Sansui SERVICE BULLETIN

Ref. CE-013

Subject: MODIFICATION OF THE POWER CIRCUIT
 Model: 2000A

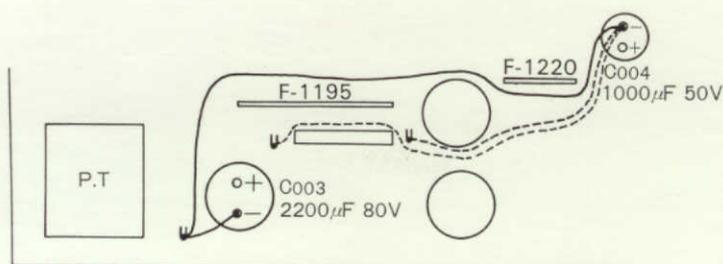
1. If noise (input shorted) is noticeable in the power amplifier sections, change the connecting wire and grounding point in the power circuit.
 See Fig. below:

2. If Hum level is noticeable on PHONO 1 or 2 of the SELECTOR, insert the ripple filter between the equalizer amplifier "F-1253 (+B) and power circuit" F-1195 (5).
 See Fig. below:
